JOINT ARCHITECTURAL BOARD/PLAN COMMISSION AGENDA
MONDAY, FEBRUARY 20, 2017
7:00 PM
BOARD ROOM
MUNICIPAL BUILDING, 210 COTTONWOOD AVE.

TO: Plan Commission
FROM: David E. Cox, Village Administrator
DATE: February 17, 2017
SUBJECT: Benchmark Secure Storage

Re: Village of Hartland
Benchmark Secured Storage-Plan Review Letter

1ST FLR - FLOOR PLAN - BUILDING 1
SCALE: 3/32" = 1'-0"

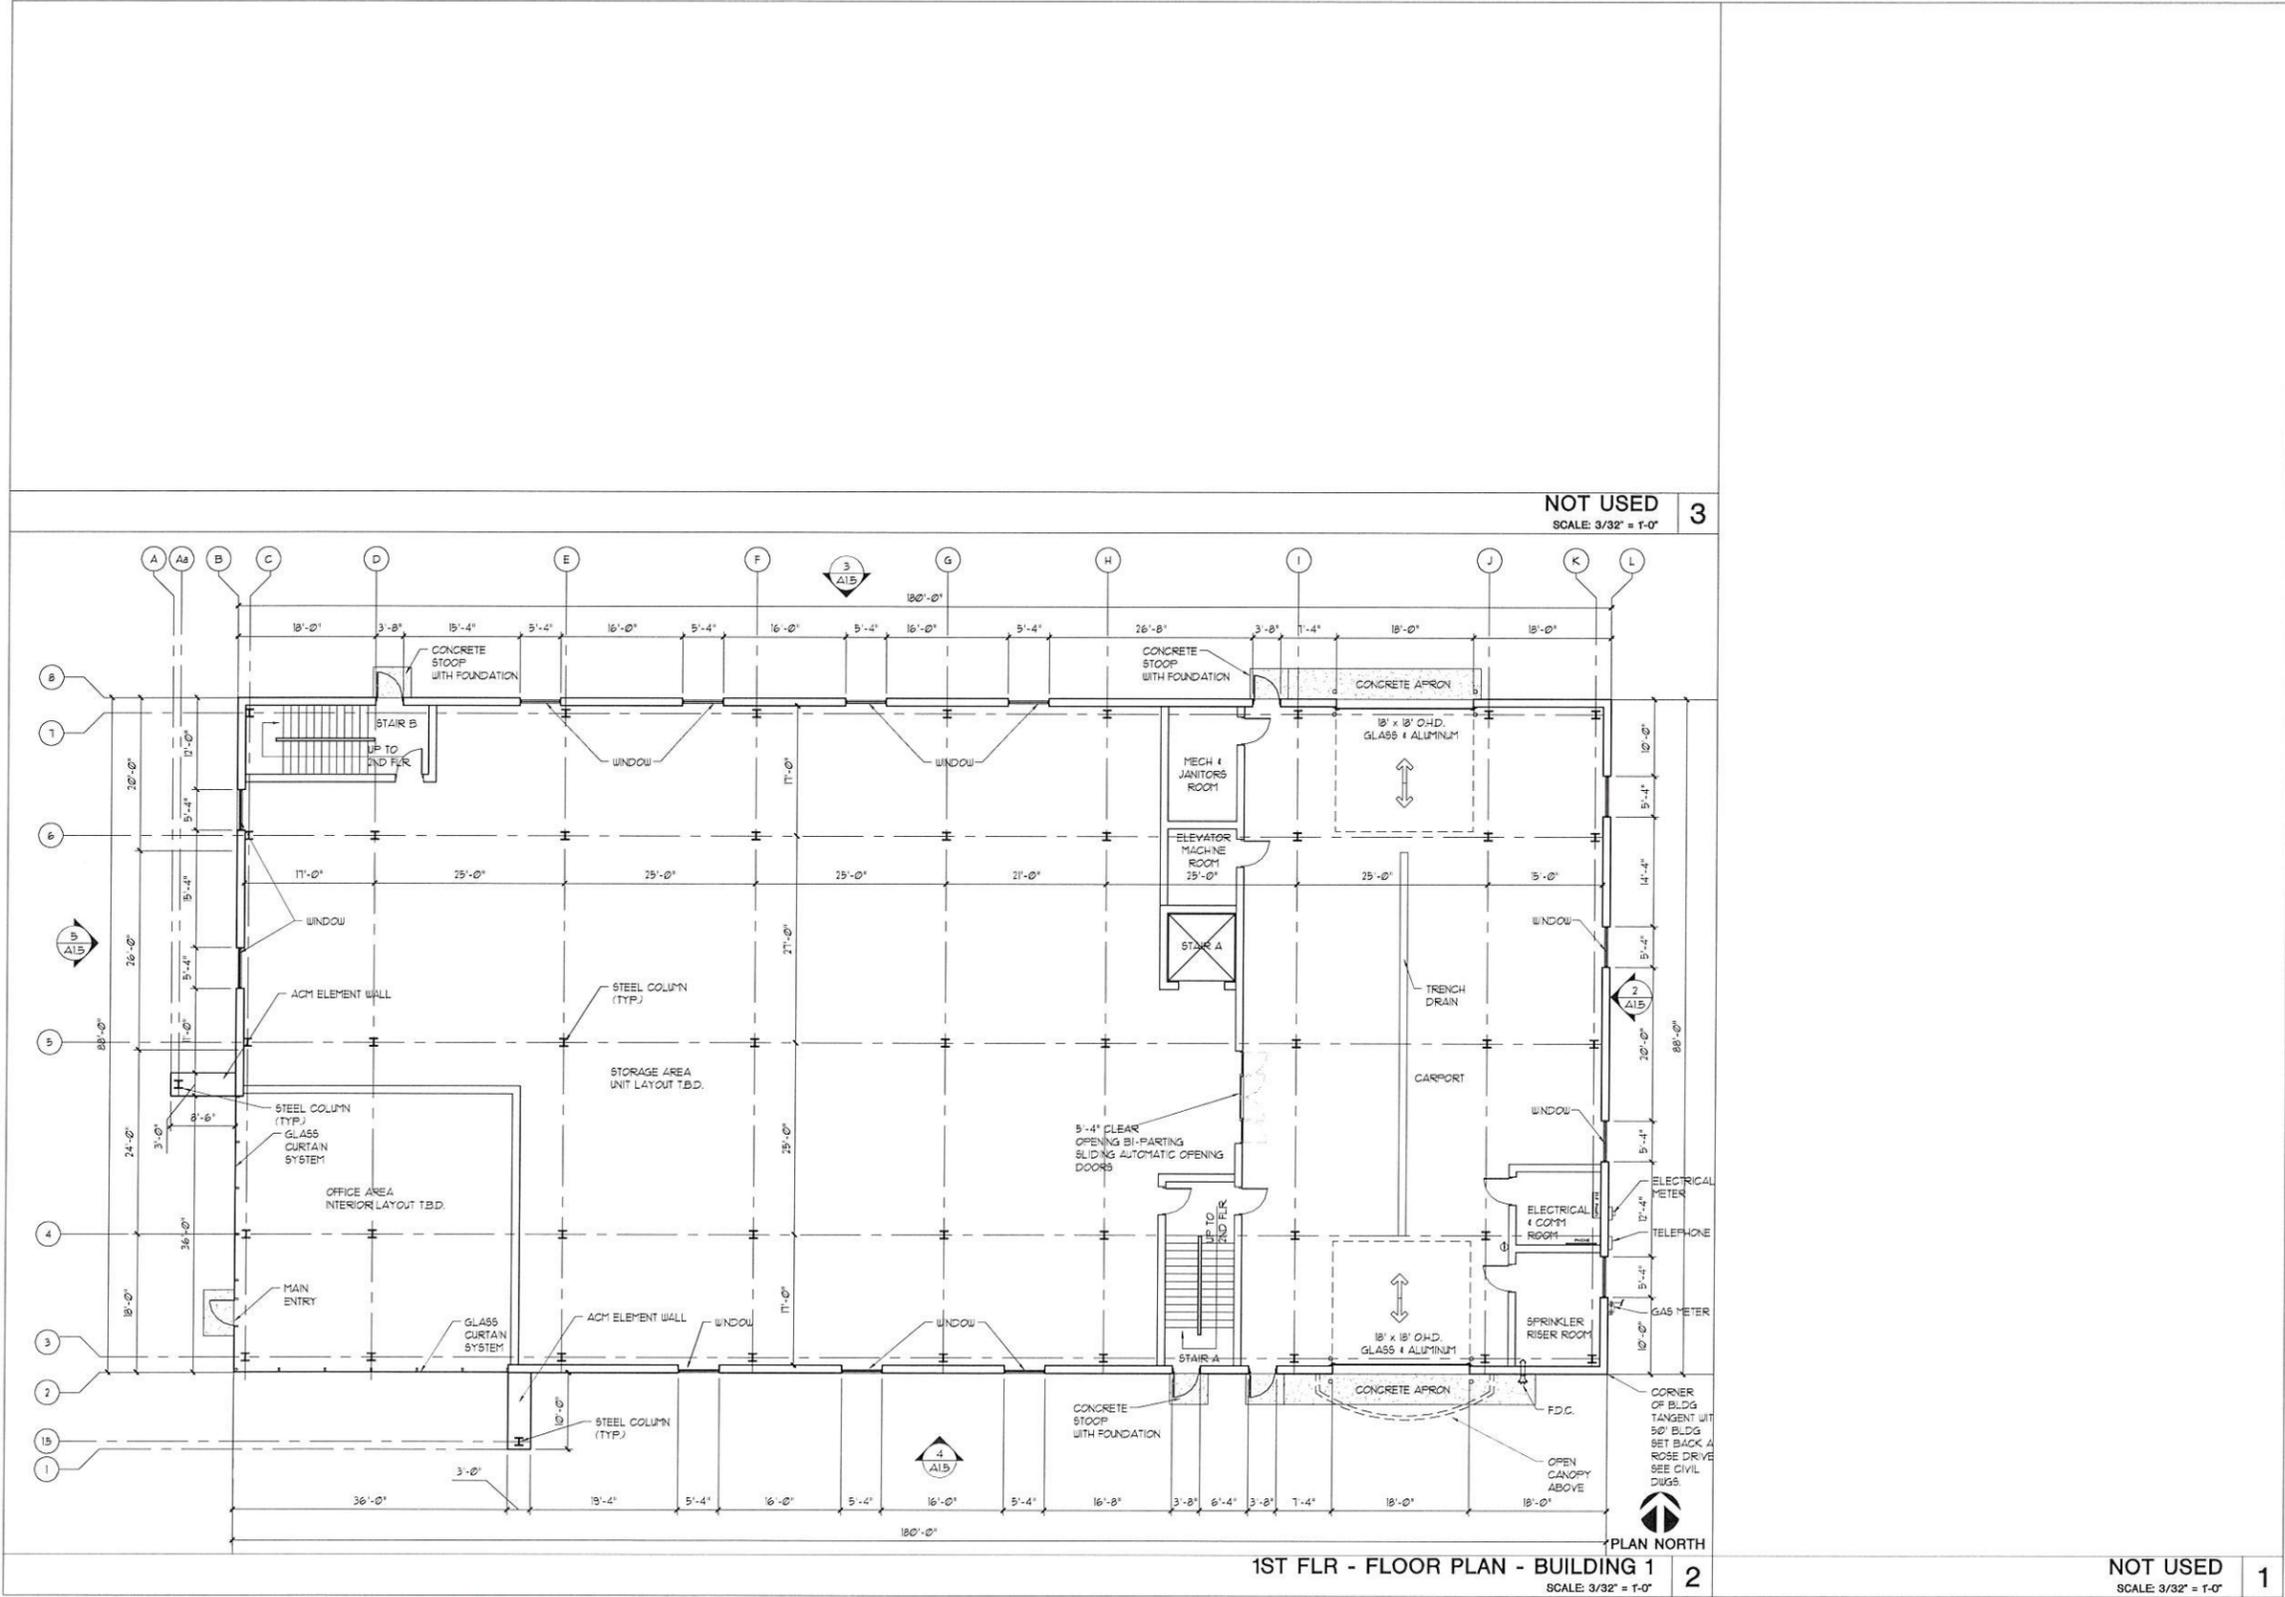
1. Update the notation for the elevator for all building #1 floor plans which currently calls it out as “stairs”.
2. Install a cleanout for the trench drain before it connects to the sanitary lateral.
